**INTERVENORS WRITTEN PRESENTATION IN OPPOSITION TO
HYDRO RESOURCES, INC.'S APPLICATION
FOR A MATERIALS LICENSE
WITH RESPECT TO:**

GROUNDWATER PROTECTION

WRITTEN TESTIMONY OF MICHAEL G. WALLACE

On behalf of Eastern Navajo Diné Against Uranium Mining ("ENDAUM") and Southwest Research and Information Center ("SRIC"), Michael G. Wallace submits the following testimony regarding ground water issues regarding Hydro Resources Inc.'s ("HRI's") amended application for a source materials license.

Figure 3.10. Modeled groundwater flow pathways for the Unit 1 and Crownpoint sites.

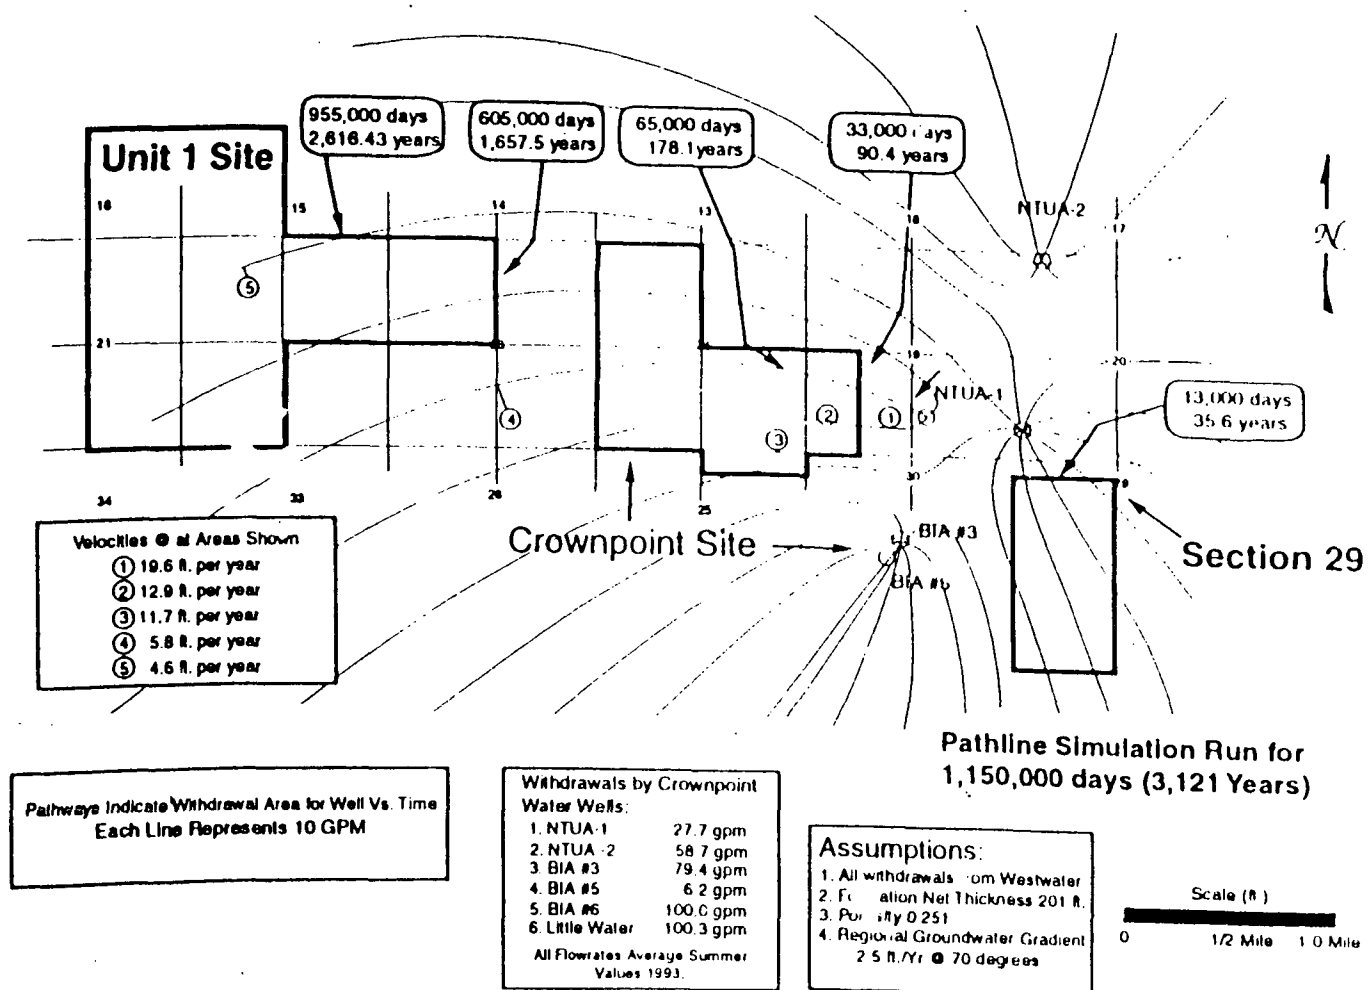
Modeling of ambient and operational flows in the Westwater Canyon was conducted by HRI. Though details are not given, it appears that the unit was considered to be hydraulically **uniform, isotropic and perfectly confined**.

The above fails to consider

FIGURE
10

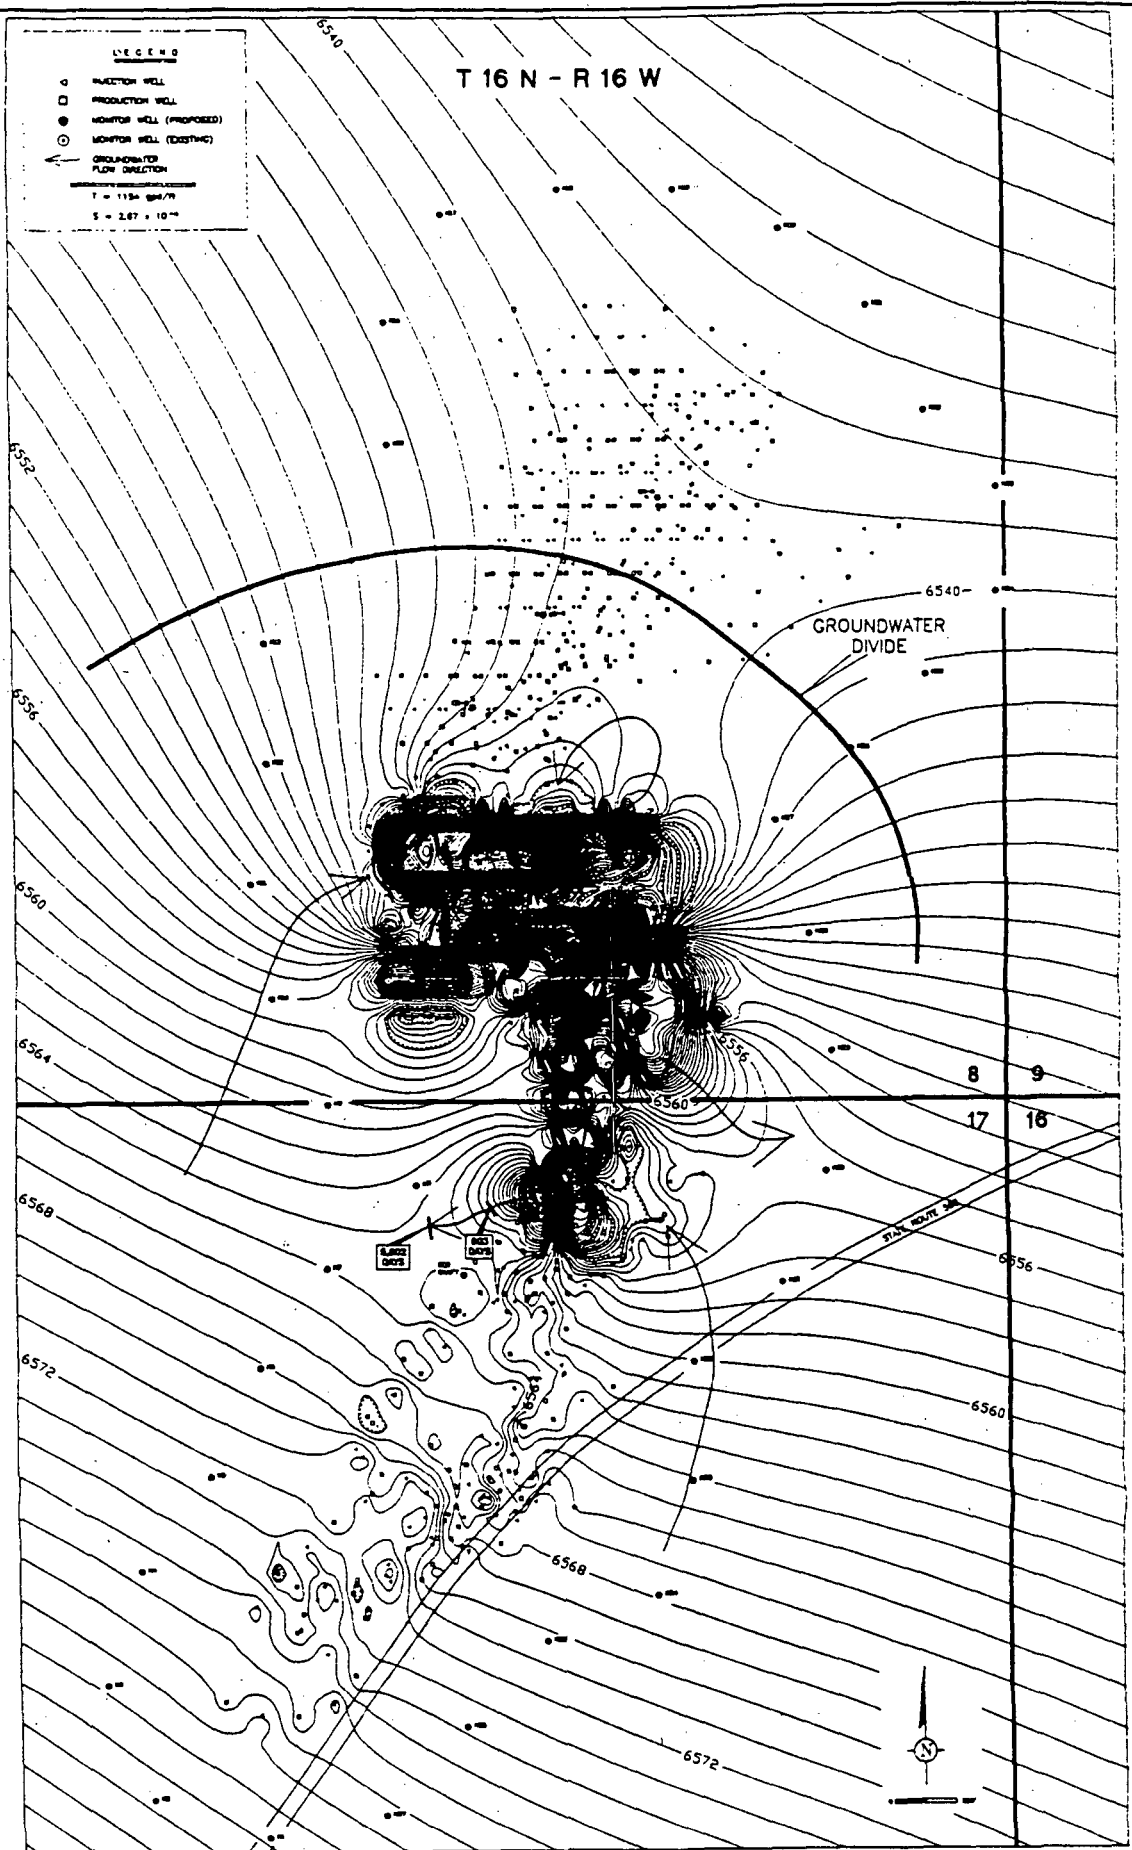
In examining the diagrams in the Geraghty and Miller report, I noticed that not all pathlines crossed head contours at right angles. For example, in Figure 10, the lower center pathline that forms a U shape crosses seven head contours, from left to right. Clearly, the sixth contour it crosses, just below its arrowhead, is not crossed at a 90 degree angle, thereby violating Rule #1. Had the pathline been drawn correctly, it would have indicated a significantly different trajectory. Many of these pathlines or others, if drawn correctly, would show fluid leaving the mine zone and escaping into the general aquifer. I can only conclude, as a professional in this field, that the pathlines were drawn in a manner that could mislead a reviewer into believing that containment of lixiviant is demonstrated, where in fact, it is not.

Figure 4. Revised groundwater divide and groundwater pathlines for modeled groundwater flows at the end of restoration at Crownpoint site Wellfield No. 4. Adapted from Geraghty and Miller, 1993, Figure 9.

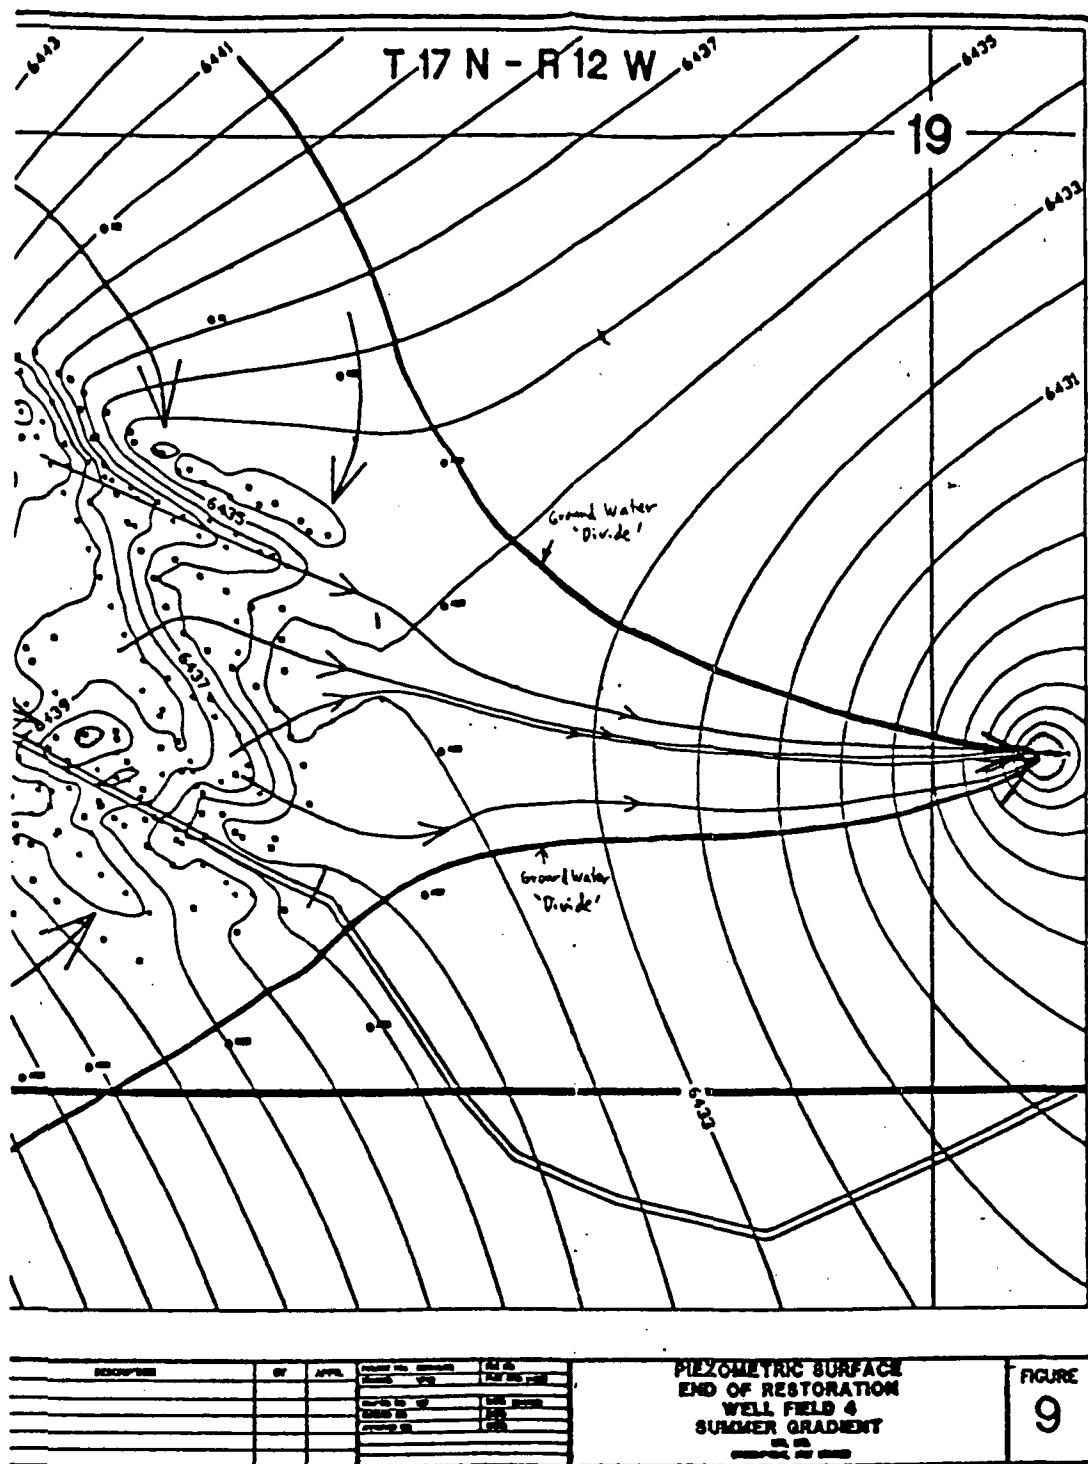
Another example is seen in Figure 9, where five pathlines are shown, all generally converging upon a central location. The arrow of the long pathline located at the lower center of the diagram is about to cross the same head contour (the 6439 value) twice. This, of course, violates Rule #2. Even of more concern is the next pathline to the right that roughly parallels the so-called groundwater divide line. Clearly, at its arrowhead, it

To illustrate the correct direction of water flow on Figure 9, I have drawn, by hand, my best estimate of the correct flow pathlines and groundwater divide lines; this revised Figure 9 is attached hereto as **Exhibit K**. My version of the diagram shows groundwater

divide lines that terminate at a single location: the NTUA-1 water supply well.⁷ Of equal importance are the groundwater pathlines that emerge from the mine area and flow directly into NTUA-1 well. These flow paths are dictated by the contour lines generated by the computer model used by HRI's consultant and by application of the strict rules for drawing ground water divides stated above. The difference between my divide lines and the faulty ones submitted by HR1 is that I have followed the rules, and I have made clear that the divides are hand drawn.

Figure 2. Plot of drawdown points for monitoring well CP-2 matched to Modified Hantush Curve.

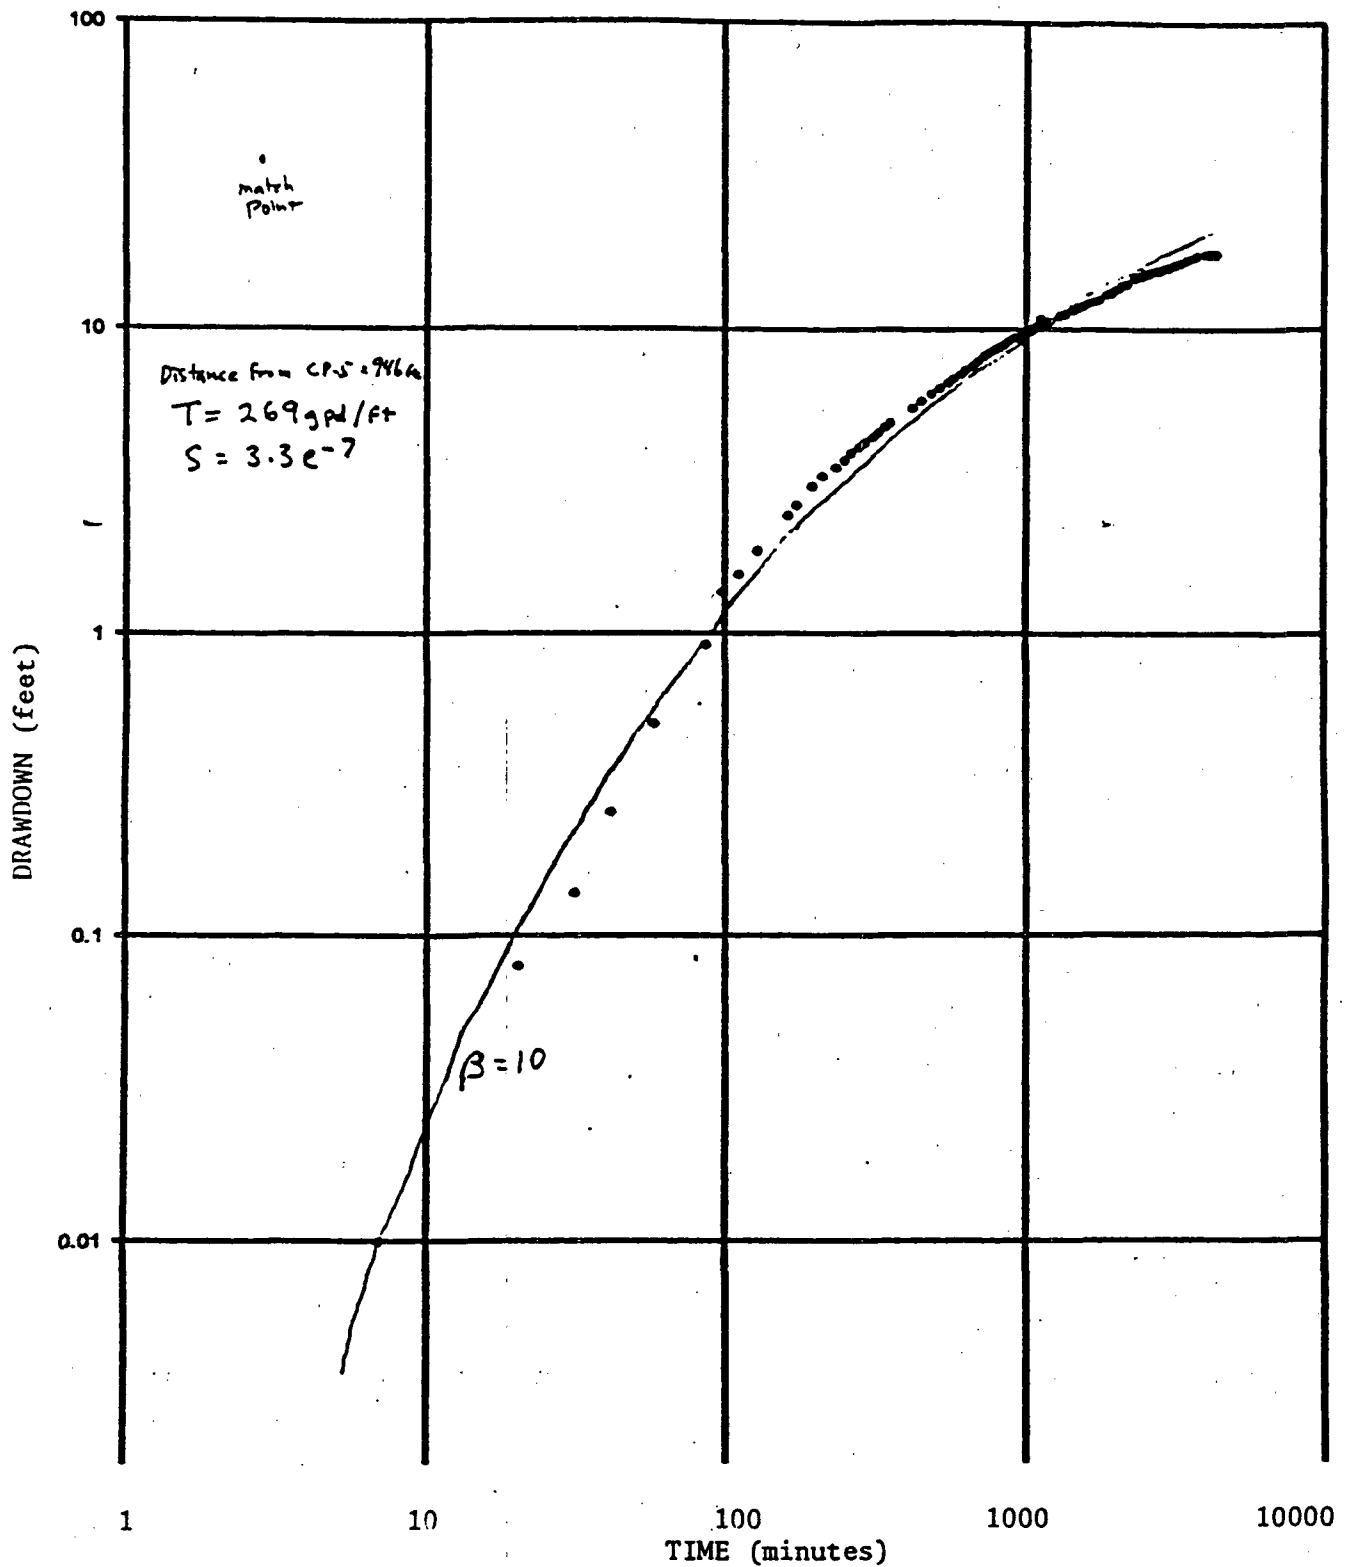
I then examined HRI's "Theis Curve Fit" plots for the same two monitoring wells, CP-2 and CP-3 (Crownpoint Technical Report, 1992, Figure C.2-E and Figure C.3-E, respectively). HRI's curves showed a poor "fit," or match, for drawdown points early in the pump test for both monitoring wells. This poor match was particularly evident for the first three data points for well CP-2, and for the first data point for well CP-3. This is an important point because early-time data are an important feature to match, particularly when investigating leakage. The curves are increasingly insensitive to each incremental decrease as drawdown time progresses. Therefore, the fact that HRI's plots matched the Theis-type curve, as pumping time elapsed, is not surprising. By contrast, the plots derived from my use of the Modified Hantush method shows much better matches to these early-time data than HRI's Theis-curve matches.

The results of my evaluation are shown in Figures 4 and 5, attached as **Exhibit M** to this testimony. These figures show a series of computer-generated dots plotted on logarithmic scales; the x-axis shows time elapsed (in minutes) since the beginning of the pump test and the y-axis shows water-level drawdown (in feet) for each point in time. For both plots, I overlaid the graphs on a series of Hantush-derived drawdown "type curves" published by the U.S. Geological Survey (Lohman, 1979, Plate 4). These curves represent the base case of zero leakage. Employing the prescribed methodology, and starting with the Theis-type curve, I moved the plots for each well across each successive curve until I found the curve that best "fit," or matched, the dots on my graphs. Neither of my plots matched the Theis-type, zero-leakage curve. For the plot for well CP-2, the best match was the curve representing $B = 10$; for the plot for well CP-3, the best match, especially for the point earliest in the test, was the curve representing $B = 0.7$.¹³ These
